State of Idaho
Department of Environmental Quality
Technical Guidance Committee

Technical Guidance Committee Meeting

Final Minutes

Thursday, August 18, 2016

Figure 4-9. Cross-sectional view of typical filter, valve, and meter assembly [for a noncontinuous flush system](#).

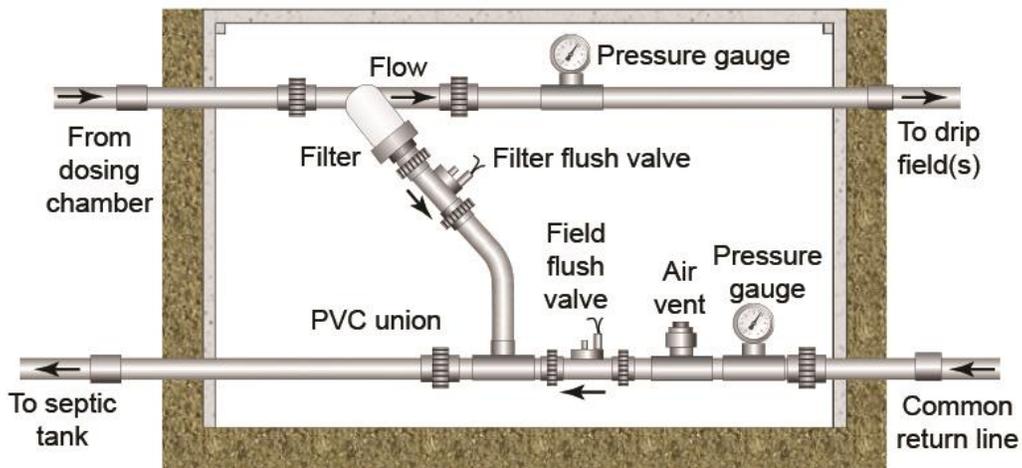
The committee requested the Tyler Fortunati have a pressure gauge added to the portion of Figure 4-9 labeled "to drip field".
